# Response to Submissions

*Alspec Distribution Warehouse*

This Submissions Report has been prepared on behalf of HB+B Property to address the matters raised by government agencies, Penrith City Council and the community during public exhibition of the proposed development at 221-235 Luddenham Road, Orchard Hills.

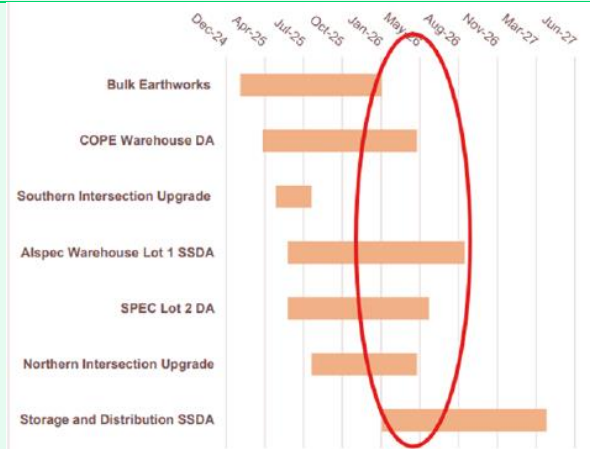
<p>d. Unimpeded access to Patons Lane: Patons Lane access must be maintained at all times to not impede Sydney Metro's construction activities.</p>		
<p><b>19. <u>Environmental Impact Statement</u></b> a. Section 3.9.1 Access and Circulation</p>	<p>This diagram has been updated.</p>	<p>Appendix J, updated traffic</p>

Summary of Issue Raised	Response	Supporting Document
<p>Figure 16: Traffic Movement plan – The colour coding is inconsistent with the identified vehicle types shown in the map.</p> <p>Recommendation</p> <p>To help minimise confusion for this public-facing document and reviewer, it is recommended to amend the entrance/exit markers so the colours are consistent with the vehicle type (i.e. entry point for trucks should be marked pink, exit points for cars should be marked blue).</p>		<p>circulation diagram</p>
<p>b. Section 3.9.2 Parking</p> <p>It is noted that 246 parking spaces are being proposed, which exceeds the requirement of 194 spaces. A similar outcome was identified by Sydney Metro and raised against the previous SSDA that was lodged (SSD-69845208), with Alspeck responding that the additional parking spaces is for future demand/development of the site. However, as per Figure 6, each warehouse development has their own parking facility.</p> <p><u>Recommendation</u></p> <p>Request the Applicant confirm what additional development they are referring to that would utilise the additional spaces for this development and SSDA-69845208. An oversupply of parking encourages additional single-vehicle trips, which in turn generates poorer traffic outcomes. Suggest the Applicant modify</p>	<p>The proposed provision of 246 parking spaces exceeds the Penrith DCP minimum requirement of 194 spaces. This allows for potential changes in tenancy, increased workforce, or operational shifts that may require more parking.</p> <ul style="list-style-type: none"> <li>▪ The DCP sets a minimum, not a maximum. Additional spaces are provided to avoid costly future modifications if demand increases.</li> <li>▪ Extra parking supports flexible leasing arrangements and anticipated industrial trends without negatively impacting the site or traffic, as confirmed by our traffic assessment.</li> <li>▪ All spaces are within each warehouse’s designated area, preventing overflow onto public streets or between sites.</li> </ul> <p>The site includes provisions for carpooling and electric vehicles, supporting sustainable transport options.</p>
